SERVICE BULLETIN

Service Bulletin No.: DA20-79-05 Rev 2

Title: DA20 A1 - Oil Line Retrofit – F3 Engine

Figure 1

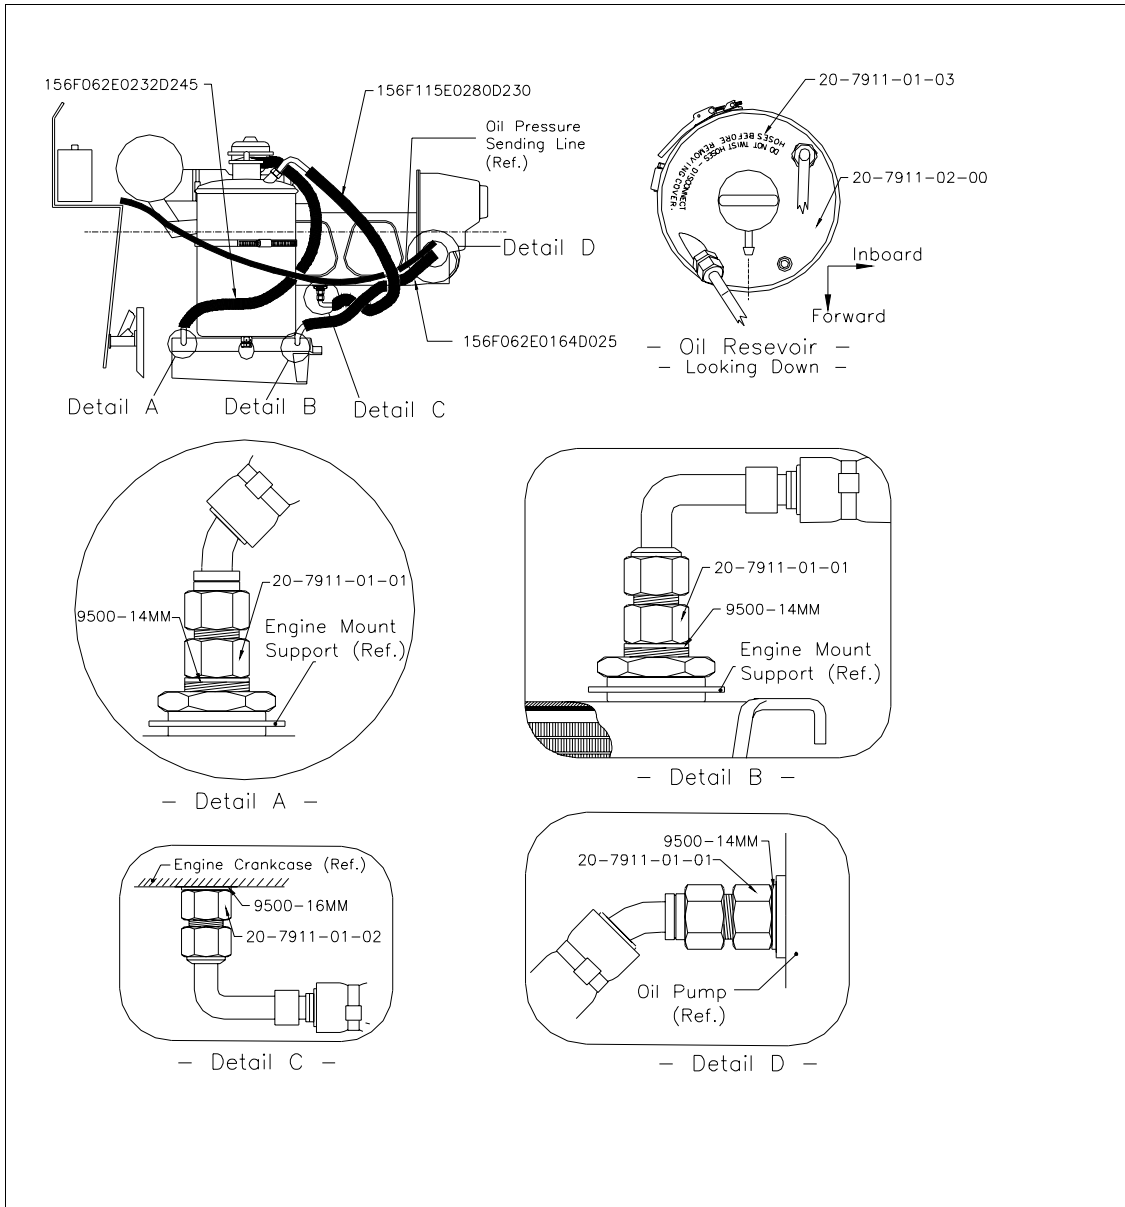
- 10.1** Remove upper and lower cowlings.
- 10.2** Remove and disassemble oil reservoir from aircraft in accordance with Rotax Maintenance Manual.
- 10.3** Assemble reservoir with supplied cover 20-7911-02-00 and O-ring 850-490 in reversed sequence of disassembly. Leave clamp loose to allow adjustment of orientation on installation.
- 10.4** Remove existing oil lines, i.e. sump to reservoir, reservoir to cooler, and cooler to pump, using a suitable container for oil.
- 10.5** Remove and discard the adapter fittings and sealing washers from oil cooler, engine sump and pump inlet.
- 10.6** Install remaining parts from kit as shown in Figure 1.
- 10.7** Torque adapters as follows:

Figure 3: Routing and securing oil lines (front, looking aft).

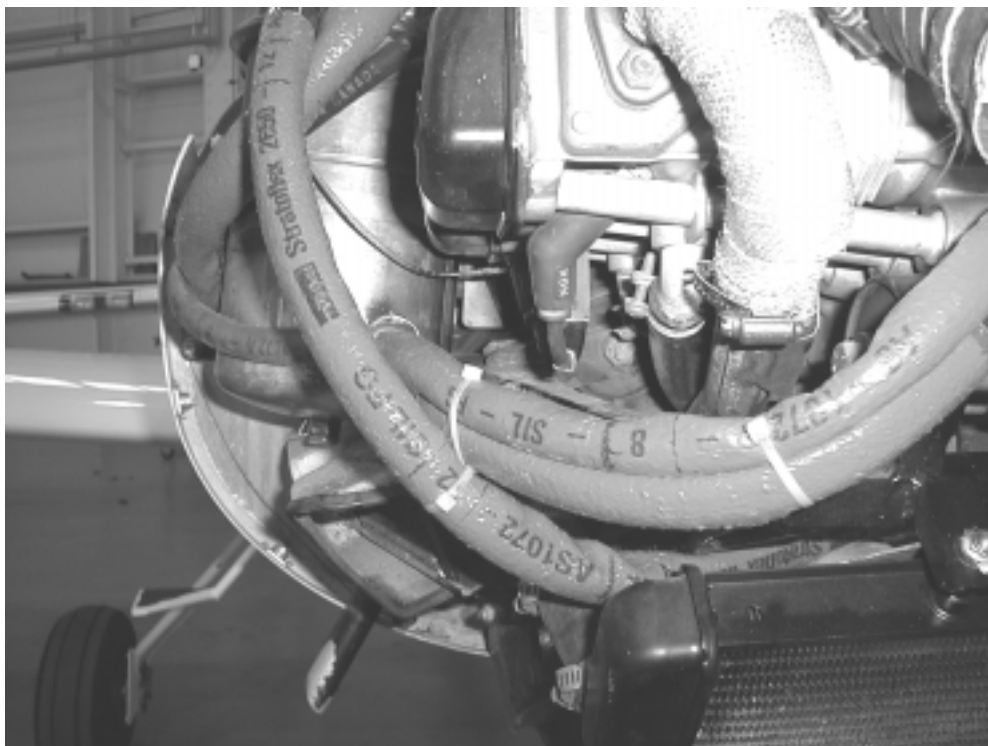
- 10.8** Route and secure oil lines as shown in Figures 2 and 3 using supplied tie-down straps, MS3367-5-9. ORIENT FITTINGS AND HOSES TO AVOID CONTACT WITH RADIATOR, ENGINE MOUNT AND CABIN HEATER SHROUD.
- 10.9** Ensure reservoir is in lowest position on engine mount. Do not allow reservoir to contact oil cooler shroud or upper surface of coolant overflow bottle.
- 10.10** Connect oil reservoir vent line.
- 10.11** Install slotted head screw M10X1X8, (p/n 440 061 not supplied) using Loctite 222 in open port of reservoir cover in accordance with Spare Parts List.
